PRODUCT ADVISORY

Data Sheet Specification Change for Intersil Products ISL8200MMREP and ISL8200MMREP-T

**Refer to:
PA13028**

Subject: **Data Sheet Specification Change for Intersil Products ISL8200MMREP and ISL8200MMREP-T**

Old Reflow Profile – PA13028

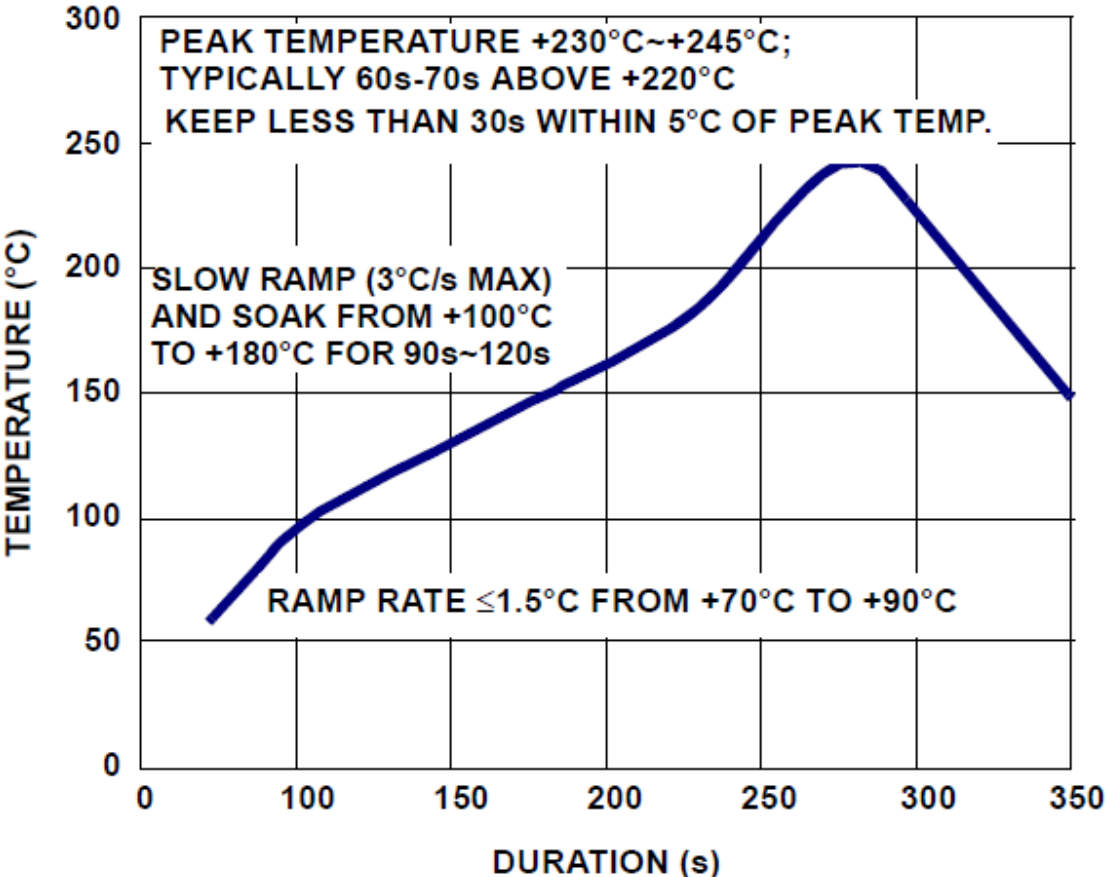
This advisory is to inform you that Intersil has updated the data sheet specification for the ISL8200MMREP and ISL8200MMREP-T products. The update includes changes to the reflow profile only. The changes include differences in the dwell time at peak temperature; peak temperature and the slow ramp soak duration. The old and new reflow profiles are contained on the following pages. There have been no changes to the electrical specifications table in the data sheet. There have been no changes made to the die/silicon or device itself. There will be no change in external marking of the packaged parts.
